MORGAN AND MORECAMBE OFFSHORE WIND FARMS: TRANSMISSION ASSETS

J18: Outline marine mammal mitigation protocol

~~September 2024~~ 5 June 2025
~~Rev~~Deadline: Deadline
2~~Application~~

Document reference: J18/F02

Figure 1.2: Example UXO clearance mitigation implementation for a high order clearance event.

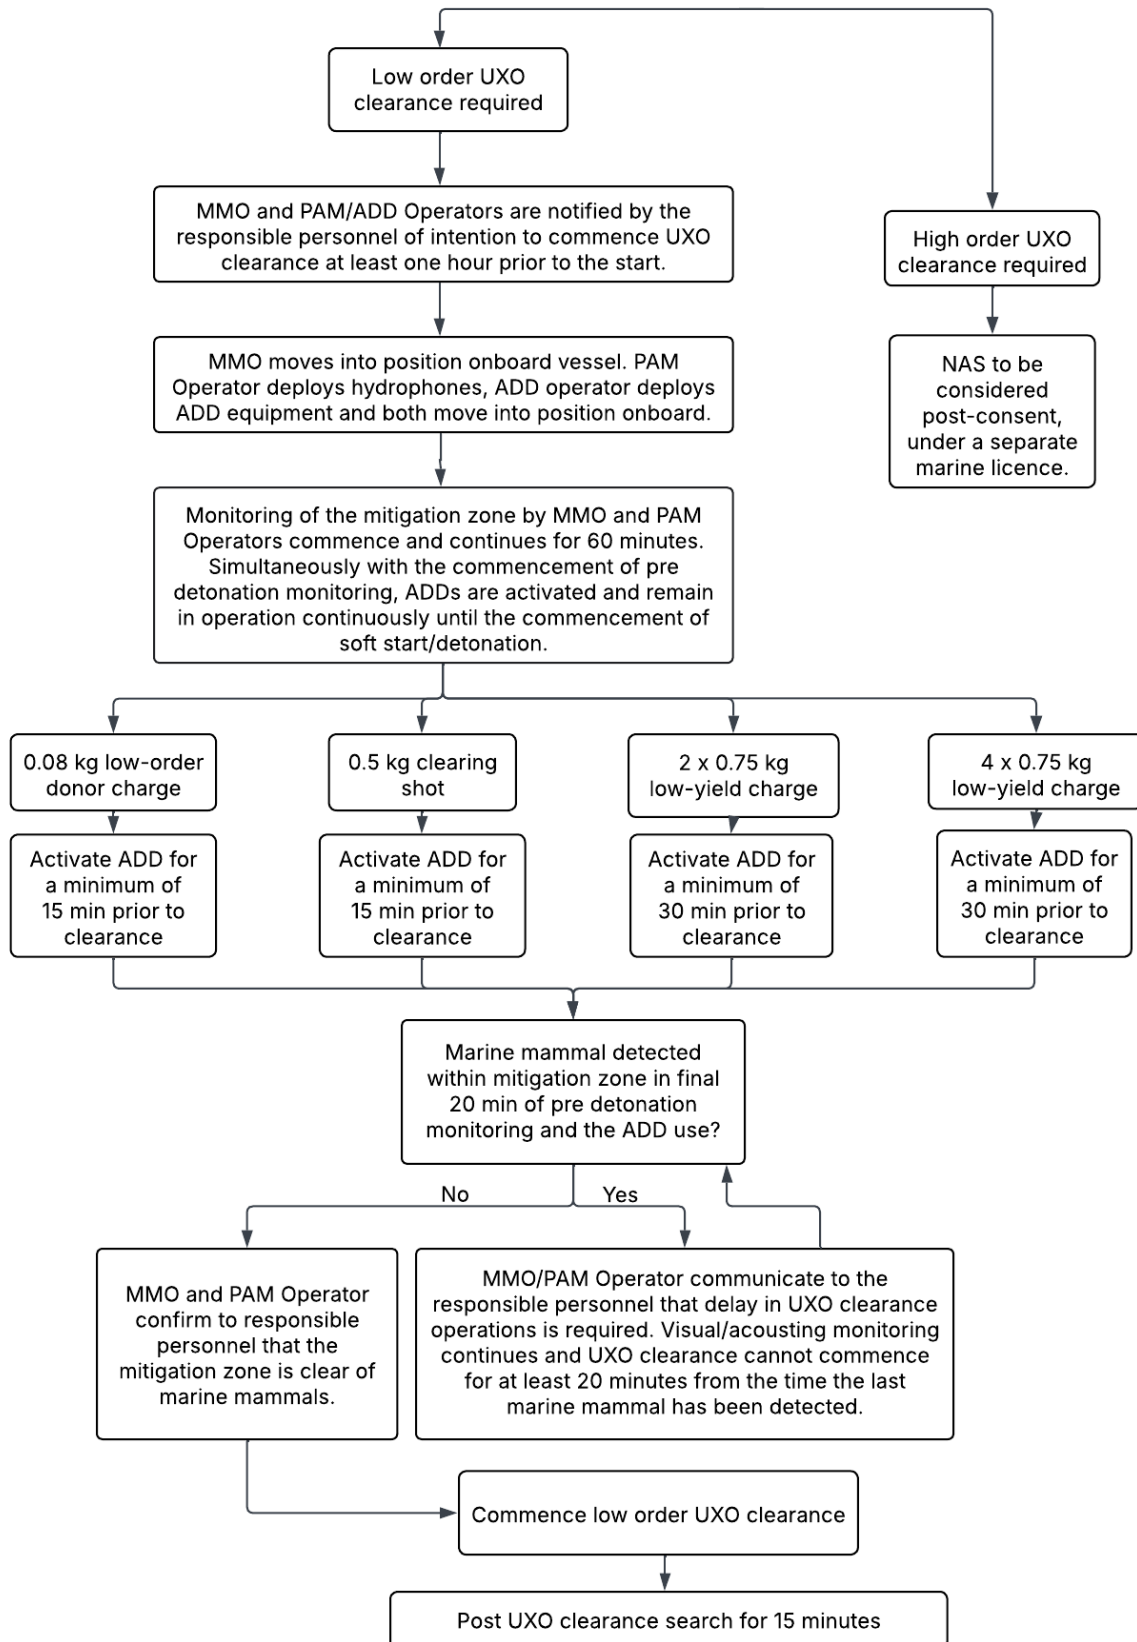
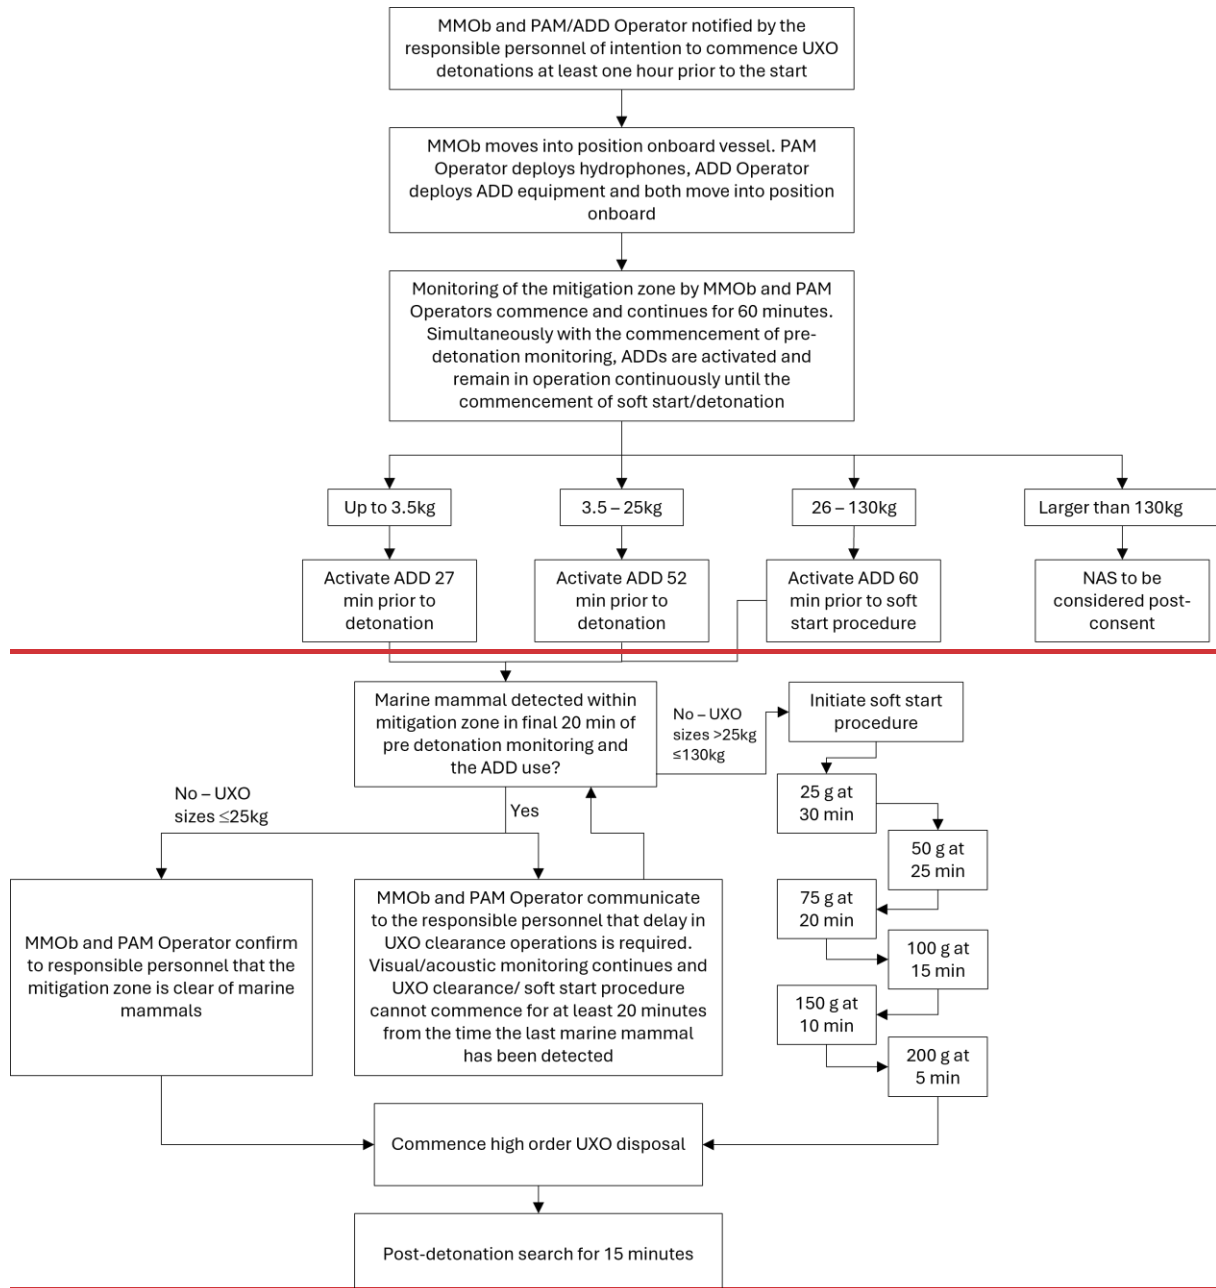
~~1.5.7.2~~ 1.6.6.2 **Figure 1.2** below provides an example of a sequence of events and the necessary lines of communication for implementing this Outline MMMP for ~~high-order~~ UXO clearance. However, this may be varied and updated post-consent, in the detailed MMMP(s).

1.5.7.31.6.6.3 The above UXO clearance mitigation plan has been developed in line with the latest Joint UXO Position Statement (Defra et al., 2025) and JNCC mitigation guidance (JNCC, 2025). The Joint UXO Position Statement states that high order UXO clearance should always be the last resort and that a minimum of three attempts should be made before high order UXO clearance is considered. Where high order UXO clearance is required a separate marine licence will be applied for (see paragraph 1.1.1.1) and therefore secondary mitigation measures will be considered post consent and will be presented in each of the detailed MMMP(s), to support the application for a separate marine licence. An overview of potential secondary mitigation measures for high order UXO clearance has been set out in **Appendix A**.
